EPC STORMWATER REVIEW COMMENTS
IN ORANGE BOXES WITH BLACK TEXT

**FINAL DRAINAGE REPORT
FOR
RETREAT AT TIMBERRIDGE
FILING NO. 3**

Job No. 1185.30

PCD Project No. SF-22-xxx

36" STORM SEWER OUTFALL 100YR HGL

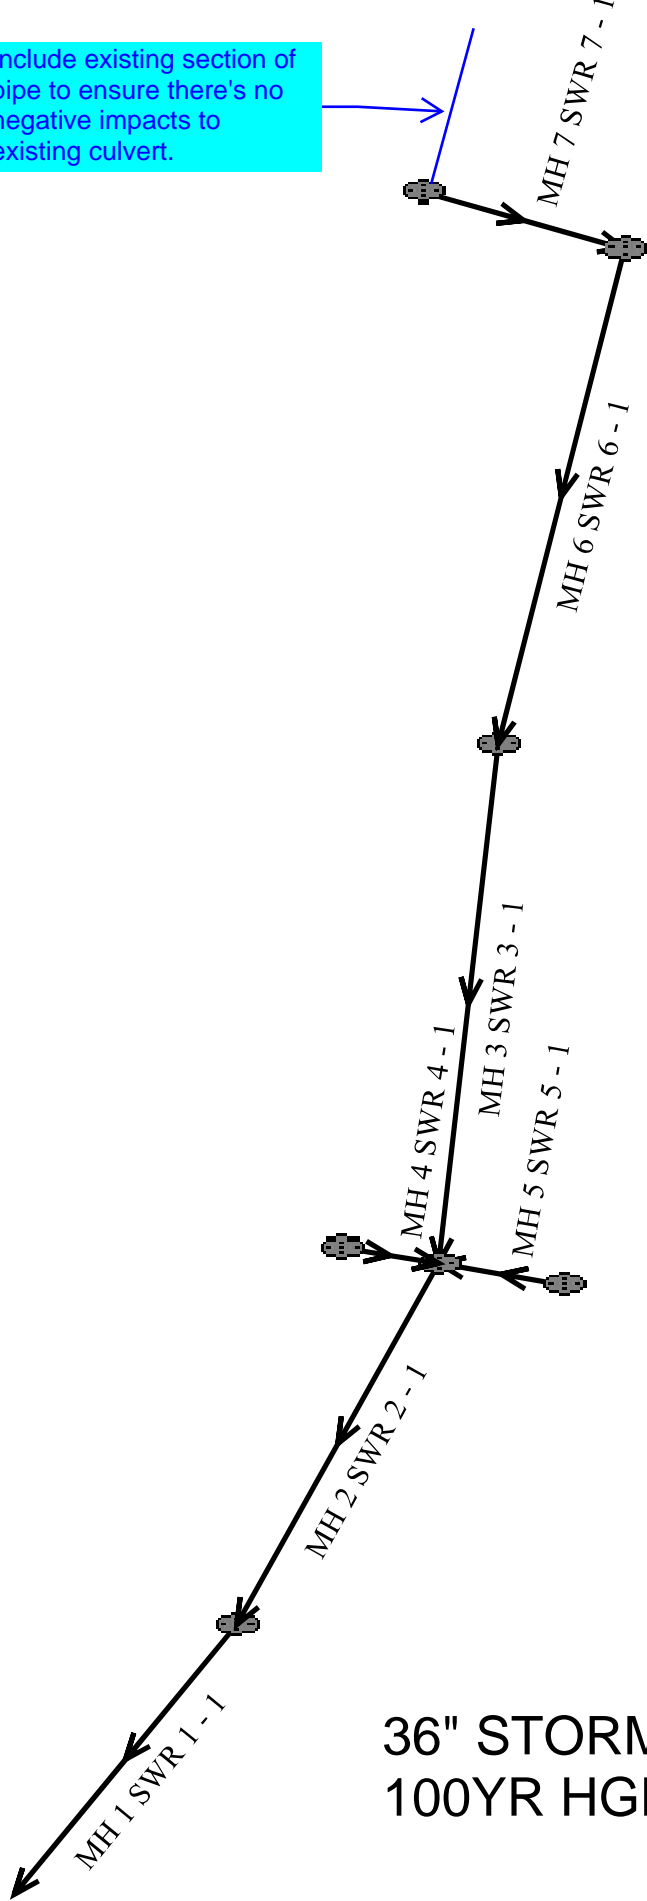
Include existing section of pipe to ensure there's no negative impacts to existing culvert.

PROJECT No.: 723523	SEQ. No.: 010	DATE: 11/3/2022
DESIGNED: XXX	DRAWN: SCC	
CHECKED: EDE	APPROVED: XXX	
SHEET NO.: 2 OF 7

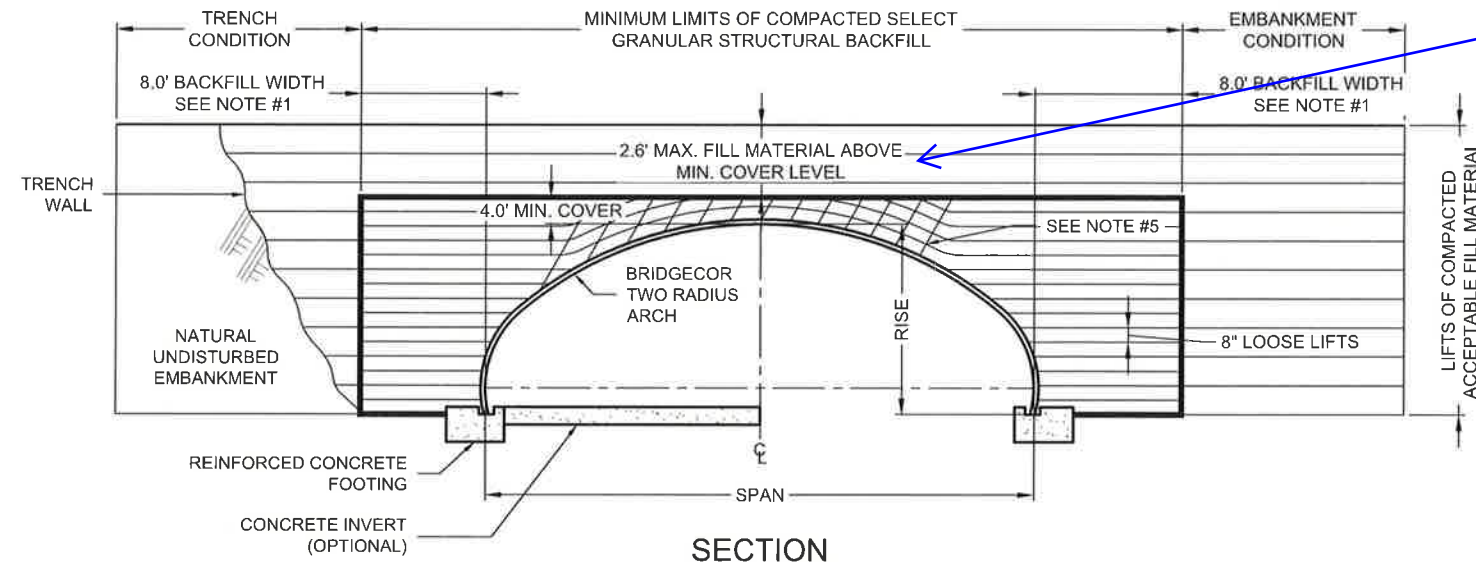
Also provide a cross section showing water and gas line crossings.
